STANDARD-TRIUMPH MOTOR COMPANY, INC.
NORTHEASTERN ZONE

BULLETIN: T-62-27

DEPT: SERVICE AND PARTS

FIG. 1

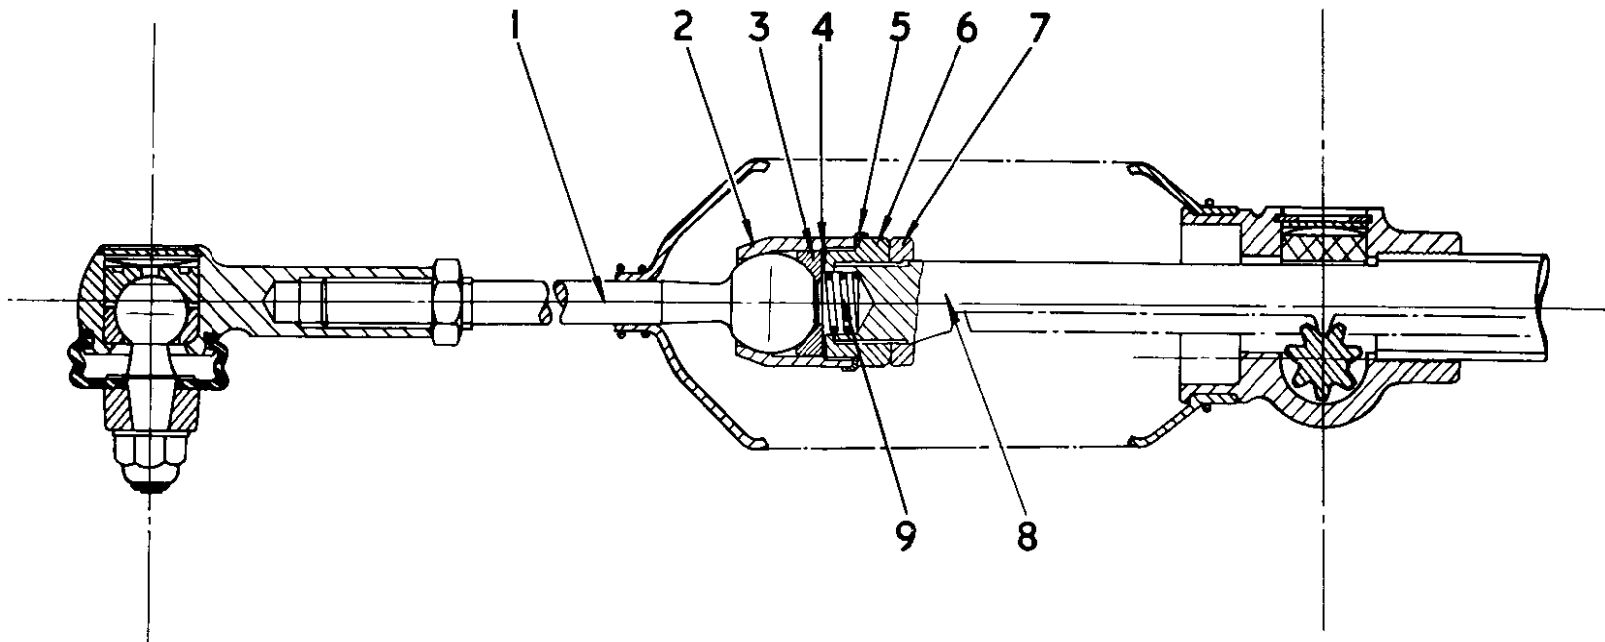
Referring to Figure 1, of attached drawings, the servicing operations are as follows:

1. Release the rubber bellows and move this clear of the ball joint.
2. Slacken the locknut (7) and remove the ball joint assembly by unscrewing the sleeve nut (6) from the rack (8).
3. If necessary, dismantle the ball joint by releasing the lockplate (5) and unscrewing the sleeve nut (6) from the cup nut (2).

3. With the cup nut held in a vise, pull and push the tie-rod to estimate the approximate amount of "ball-lift".
4. Prepare a shim pack (4) slightly thicker than the estimated "ball-lift" and insert this between the thrust ring (3) and the sleeve nut (6).
5. Add or remove shims to obtain the requisite .002" ball-lift when the sleeve nut is firmly screwed into the cup nut.

FIG. 2

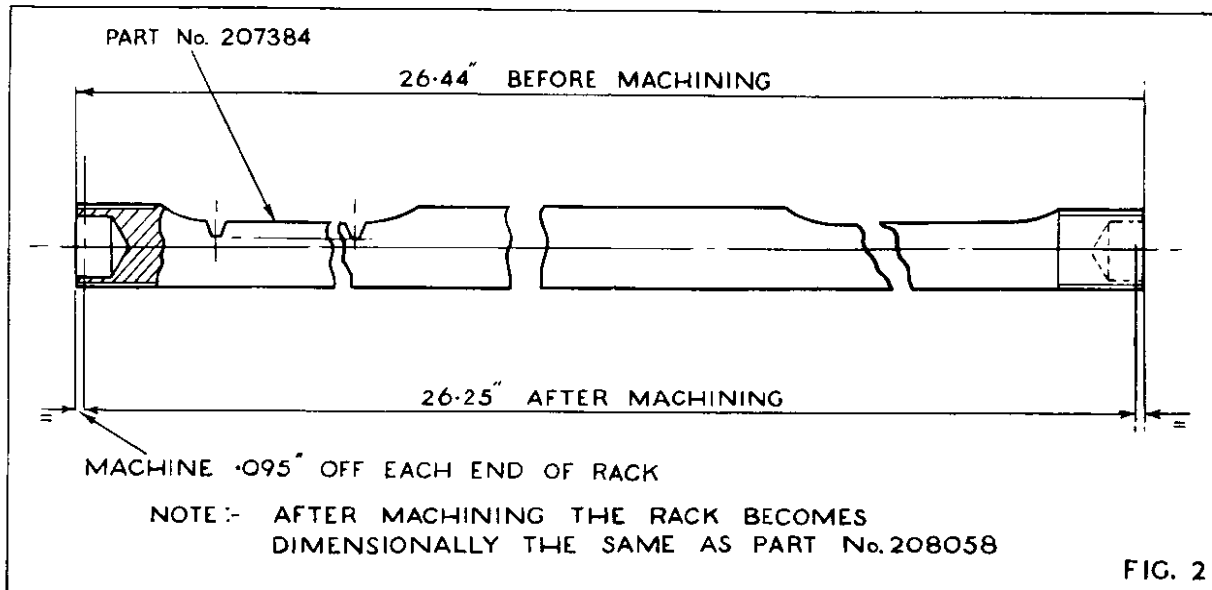
Early type inner ball joint assemblies cannot be fitted to the new steering unit, but the new ball joint assemblies may be fitted to the earlier type steering units provided that the rack is modified as shown on Figure 2.
